Product Change Notification

Product Change Notification: PCN-23-166385

RIGHT ANGLE HEADER ASSY, TIN, GOLD15, GOLD30 SMT CONTACTS W/ THRU HOLE AND SMT HOLDDOWNS.

We would like to enjoy the opportunity to do some improvements in the customer drawings in order to make them clearer and with more and better information. (Marked Copies available)

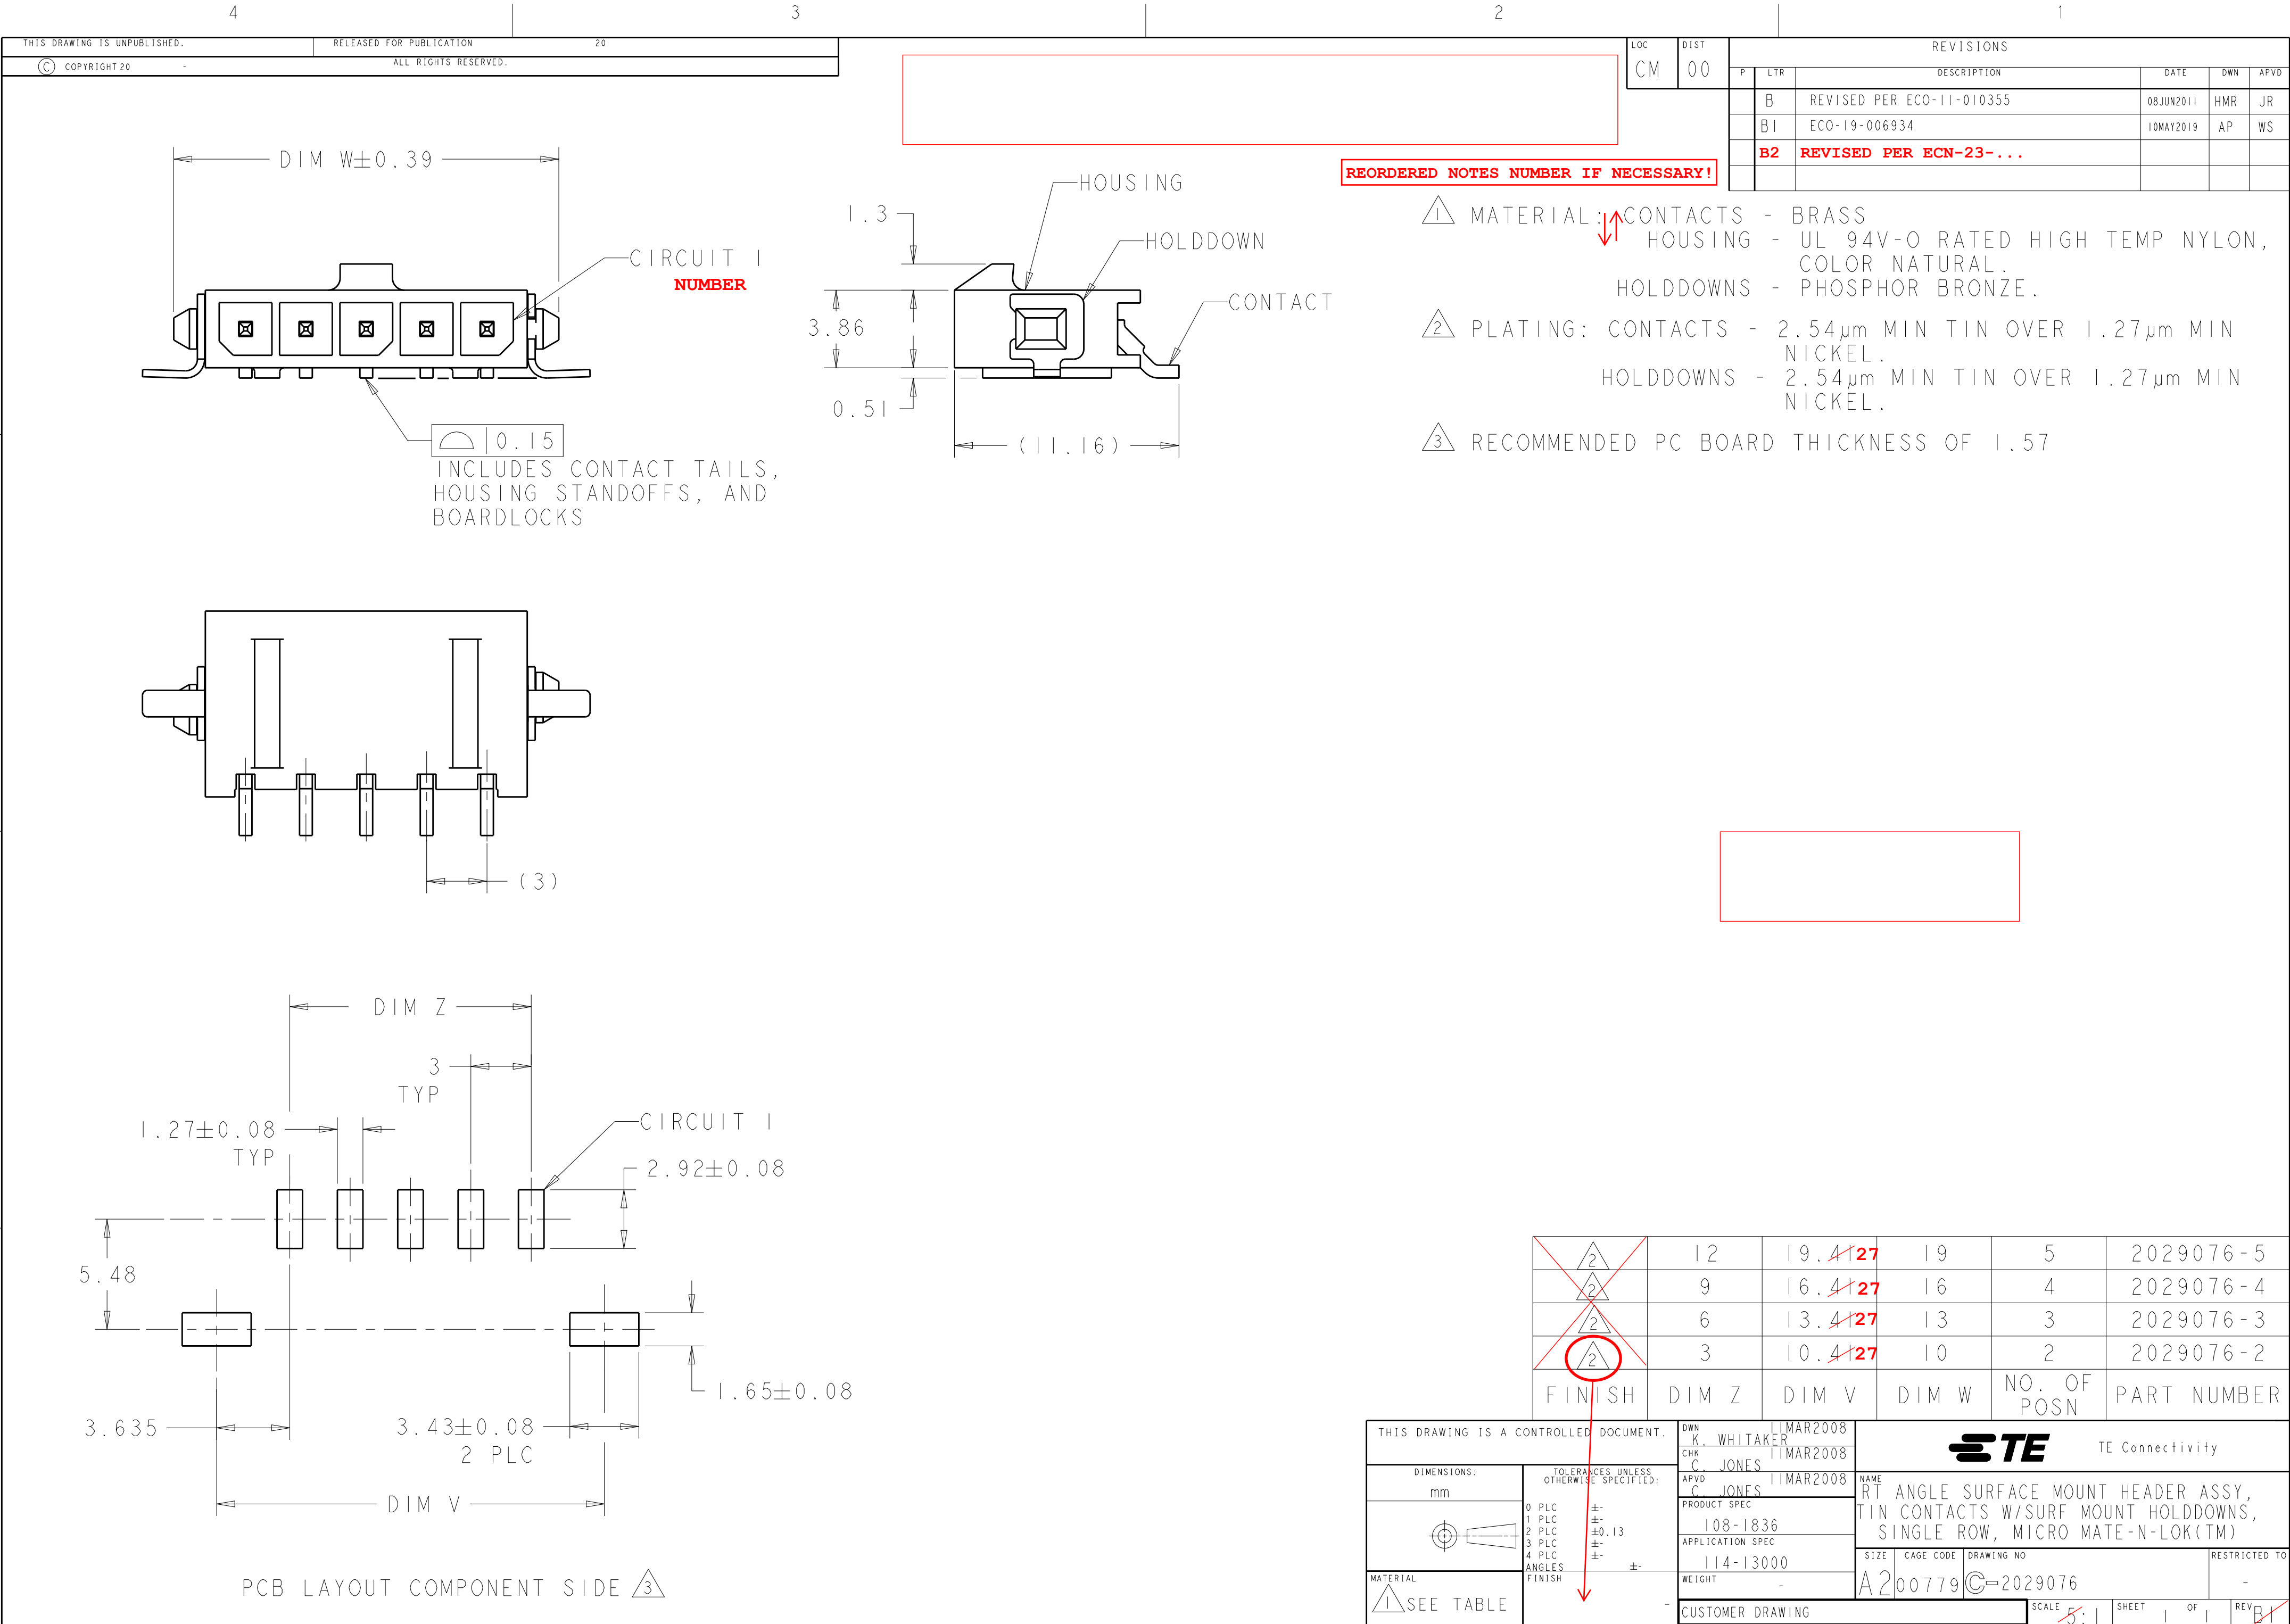
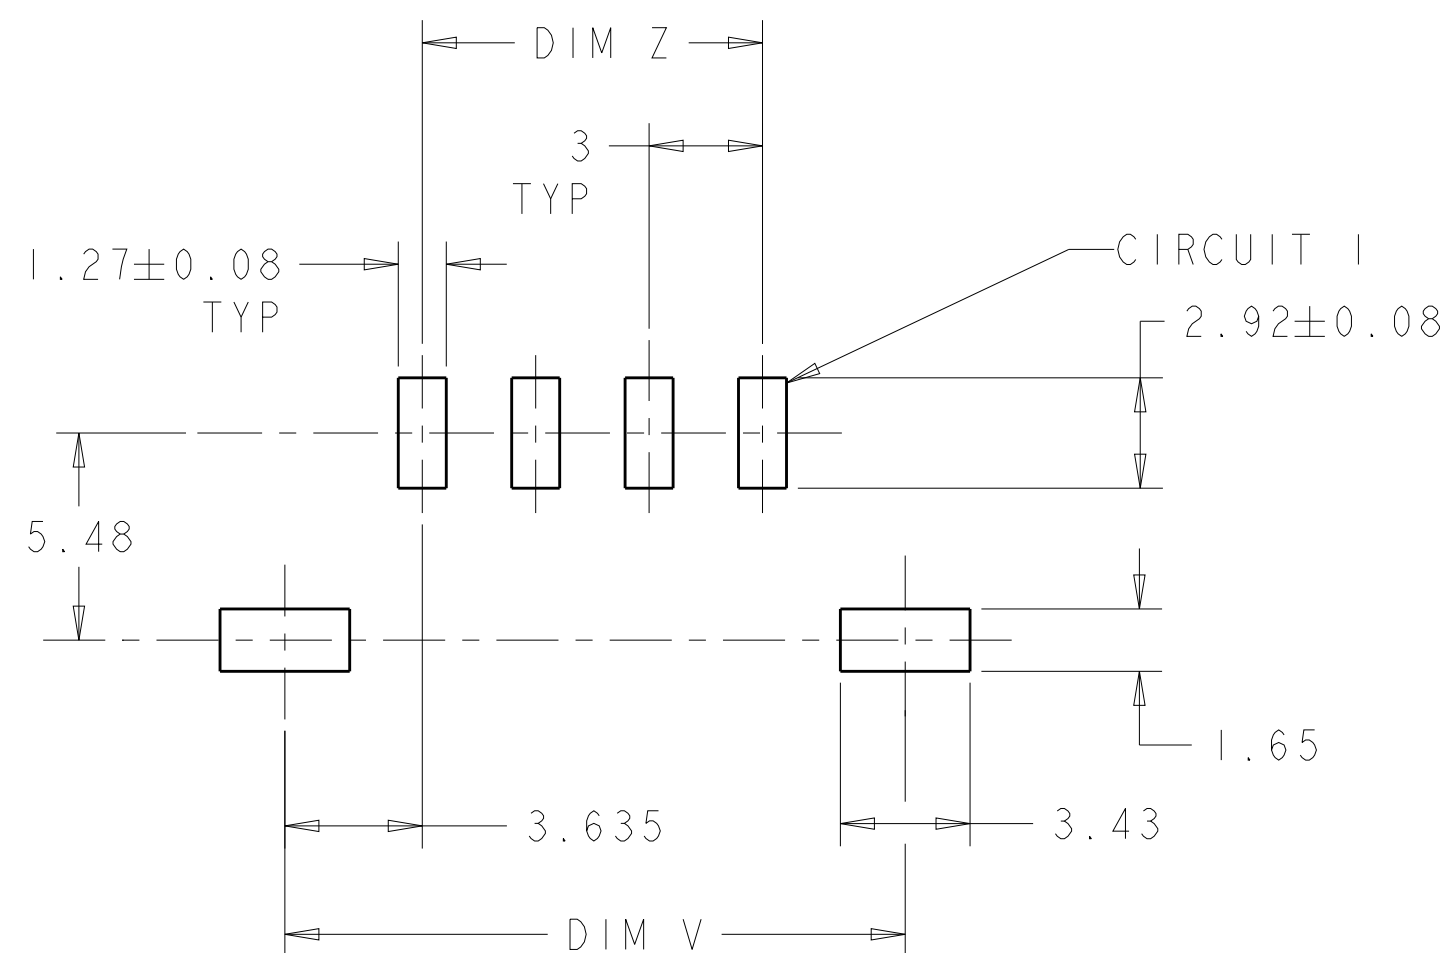
REORDERED NOTES NUMBER IF NECESSARY!

① MATERIAL: CONTACTS - BRASS
HOUSING - UL 94V-0 RATED HIGH TEMP NYLON,
COLOR NATURAL.
HOLDDOWNS - PHOSPHOR BRONZE.

② PLATING: CONTACTS - 2.54μm MINIMUM TIN OVER 1.27μm MINIMUM
NICKEL.
HOLDDOWNS - 2.54μm MINIMUM TIN OVER 1.27μm MINIMUM
NICKEL.

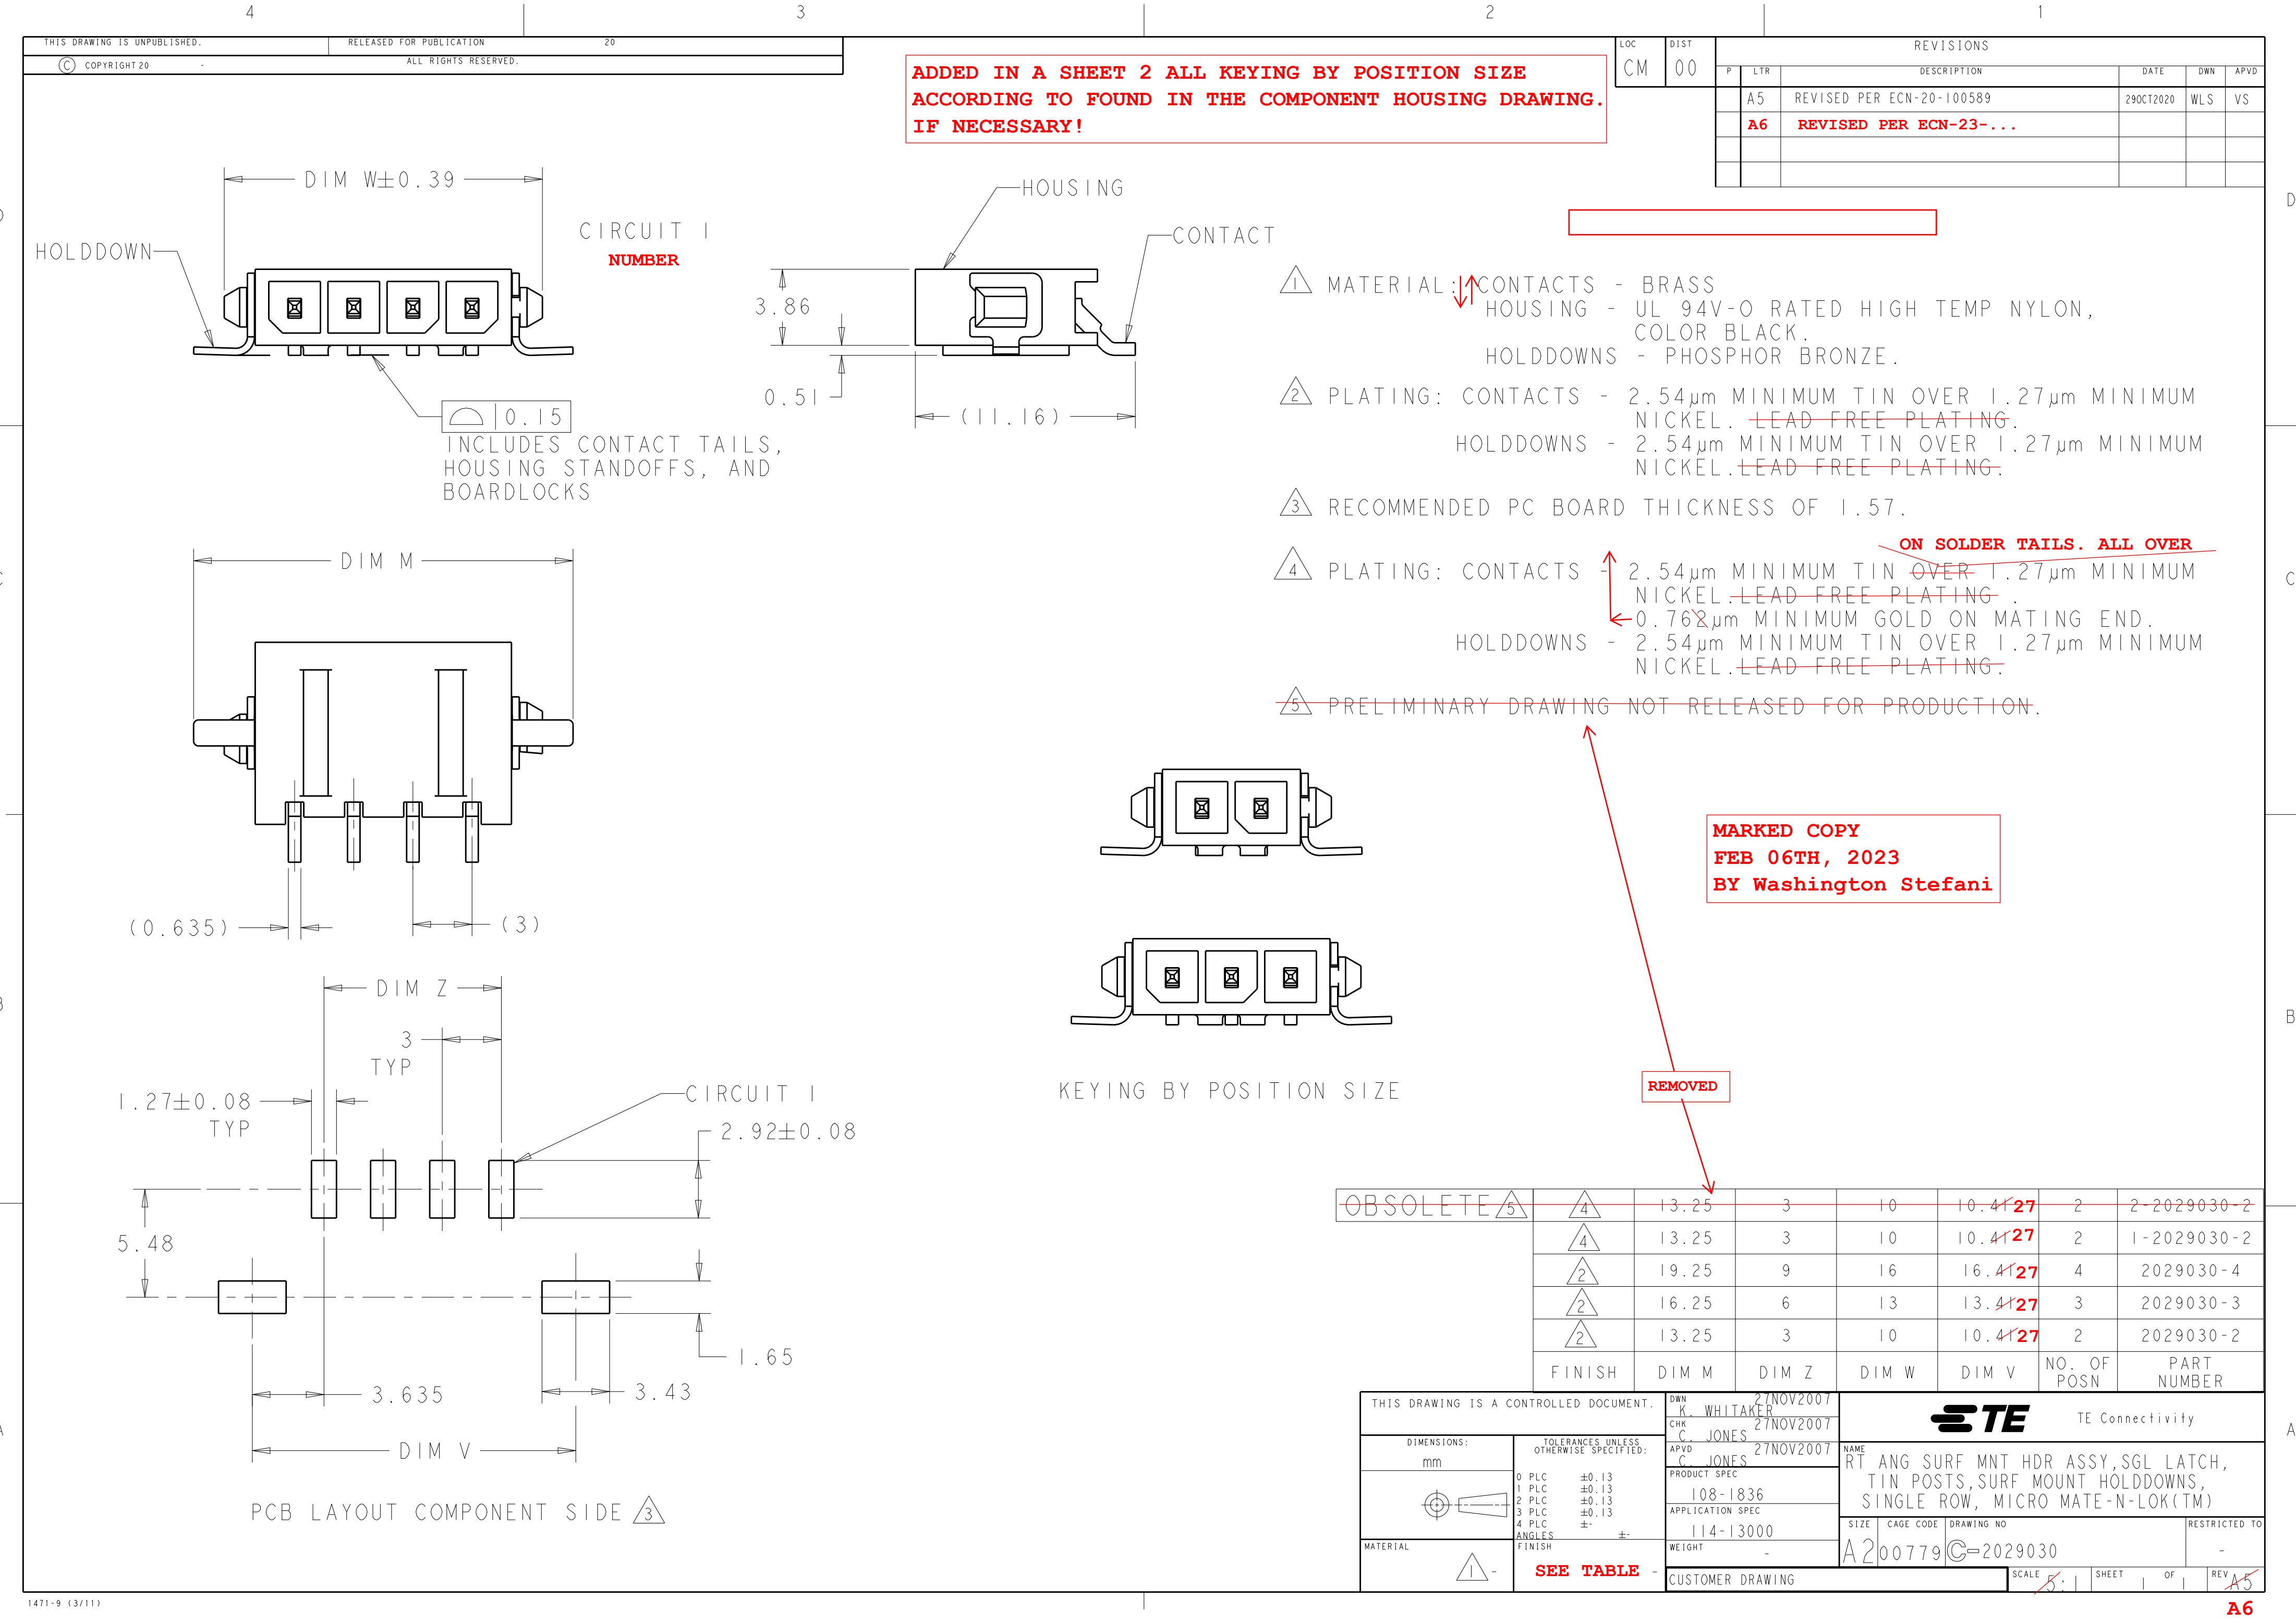
ADDED IN A SHEET 2 ALL KEYING BY POSITION SIZE
ACCORDING TO FOUND IN THE COMPONENT HOUSING DRAWING.
IF NECESSARY!

REMOVED

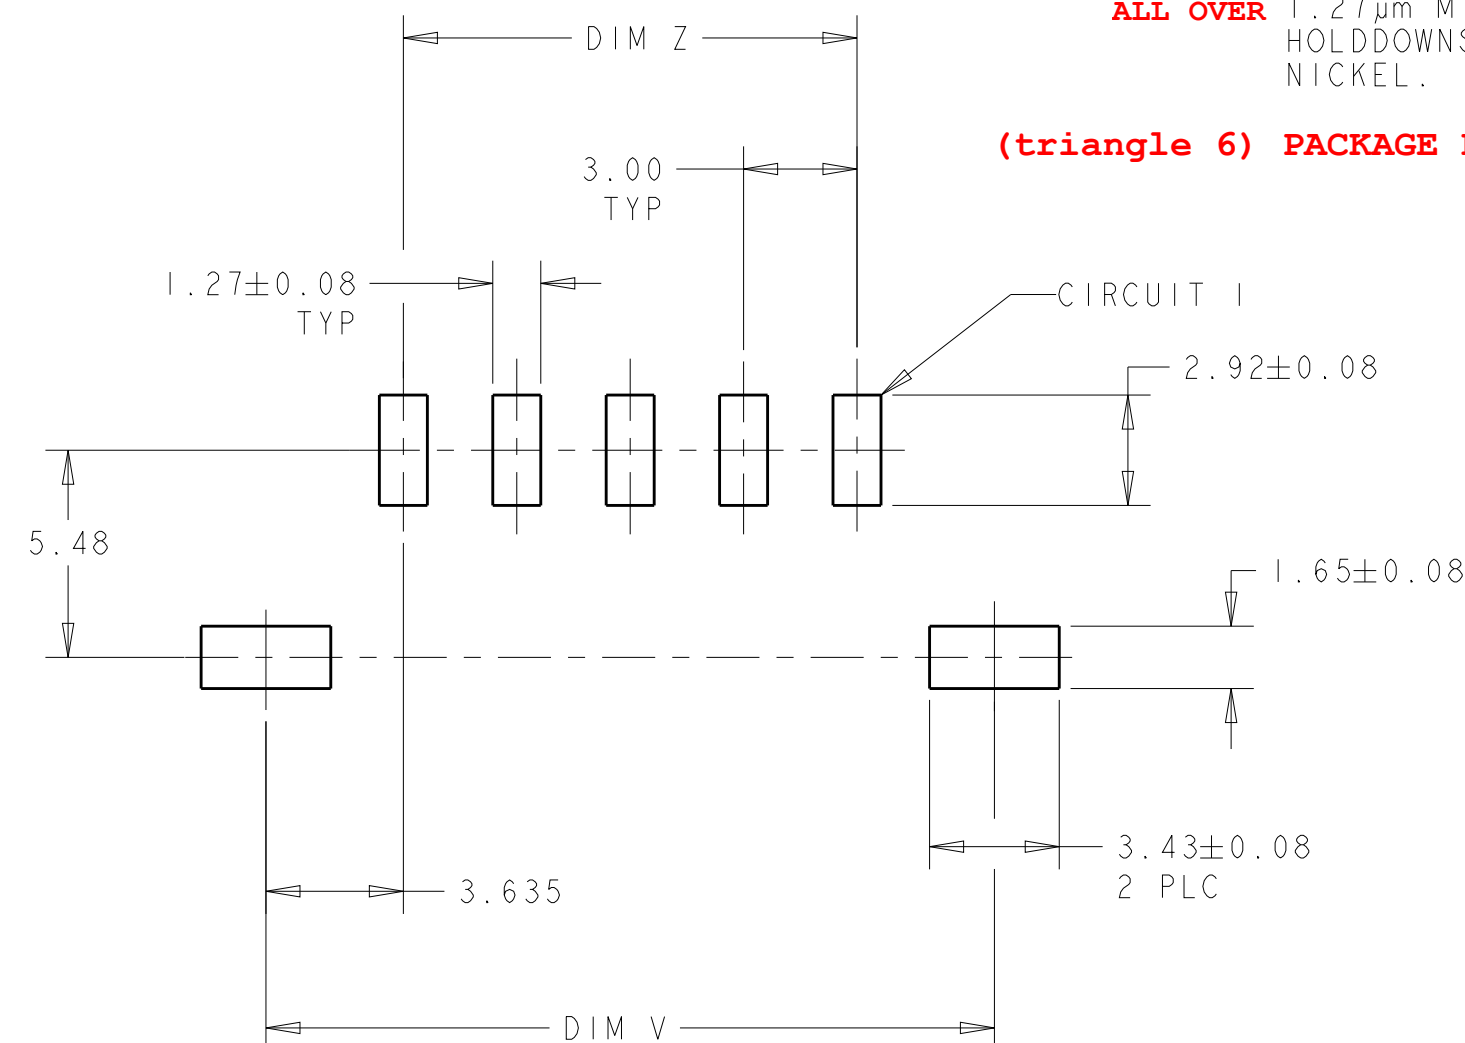
PLATING: ~~CONTACTS - 0.76 μ m MINIMUM GOLD ON MATING END,~~
~~2.54 μ m MINIMUM TIN LEAD ON SOLDER TAILS, BOTH OVER~~
~~1.27 μ m MINIMUM NICKEL.~~
 ~~HOLDDOWNS: 2.54 μ m MINIMUM MATTE TIN OVER 1.27 μ m MI~~
~~NICKEL.~~

REMOVED

5 PLATING: CONTACTS - 0.76µm MINIMUM GOLD ON MATING END,
2.54µm MINIMUM MATTE TIN ON SOLDER TAILS, ~~BOTH OVER~~
ALL OVER 1.27µm MINIMUM NICKEL.
HOLDDOWNS: 2.54µm MINIMUM MATTE TIN OVER 1.27µm MINIMUM
NICKEL.

ALL OVER
